# 客户变更通知单(Product/Process Change Notice)

PCN No.: PCN#20260518-1

| **料号 PN** | CM3421Y600R-10 | **日期 DATE** | 2026/05/18 |

| **变更内容 What the Change About** | **变更前 Before** | **变更后 After** | |

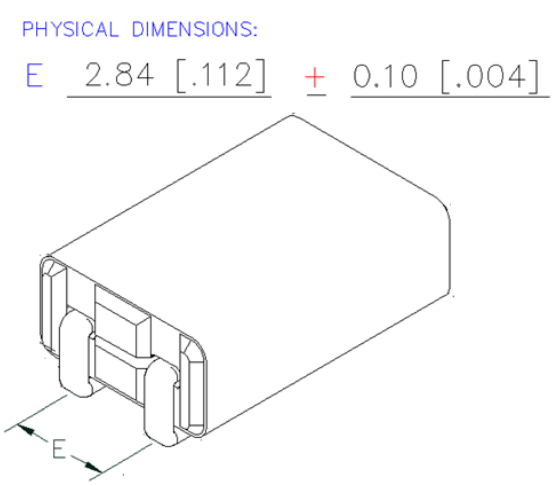
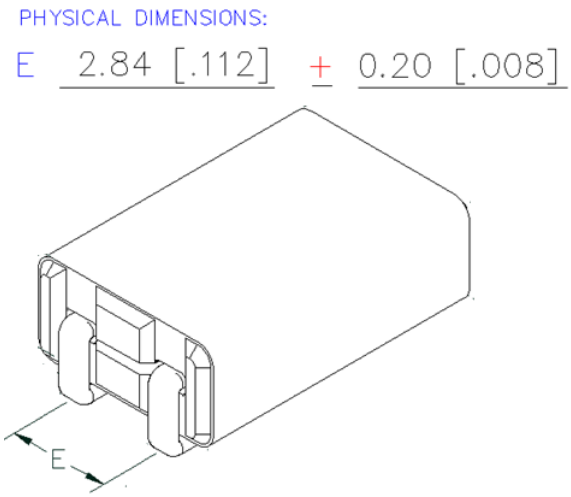
| |  |  Only change the size of 'E', do not make any other changes. | |
| **变更原因 Change Reason** | Due to the optimization of manufacturing processes and the adjustment of standardized production equipment, slight changes in dimensional tolerances can reduce unnecessary waste and rework, ensuring timely delivery and long-term supply chain reliability without affecting quality or customer application performance. | | |

| **品质数据 Quality Data** | Pass | The revised tolerance range has completed full validation and reliability verification. The relaxed limits remain fully compliant with functional performance, interchangeability, safety and application requirements, with no negative impact to end product fit, assembly, performance or service life. | |

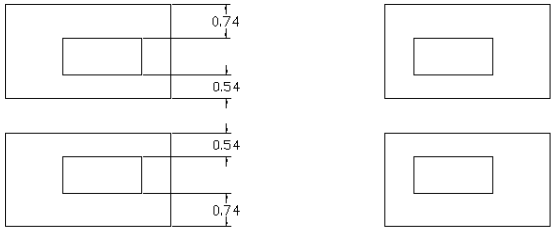
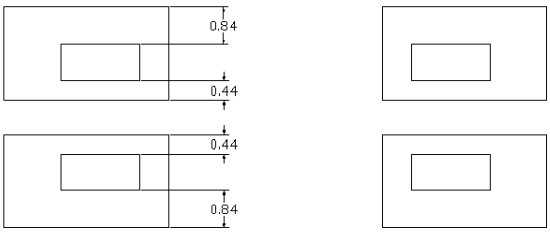
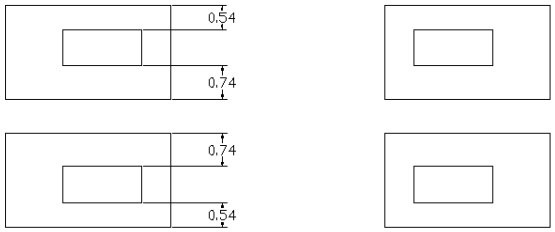
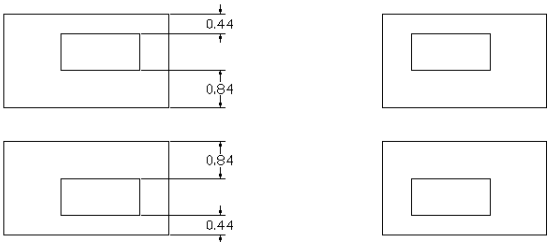
| **结论 Conclusion** | Laird suggests matching the solder pad pattern with (2.84−0.1) Actual usage situation<br>  <br><br>Laird suggests matching the solder pad pattern with (2.84−0.2) Actual usage situation<br>  <br><br>Laird suggests matching the solder pad pattern with (2.84+0.1) Actual usage situation<br>  <br><br>Laird suggests matching the solder pad pattern with (2.84+0.2) Actual usage situation<br>  <br><br>The relaxed limits remain fully compliant with functional performance, interchangeability, safety and application requirements, with no negative impact to end product fit, assembly, performance or service life. The change corrects historically over-tight legacy tolerances helping stabilize production variation, reduce unnecessary scrap and rework, and ensure consistent on-time delivery and long-term supply chain reliability, without compromising quality or customer application performance. |
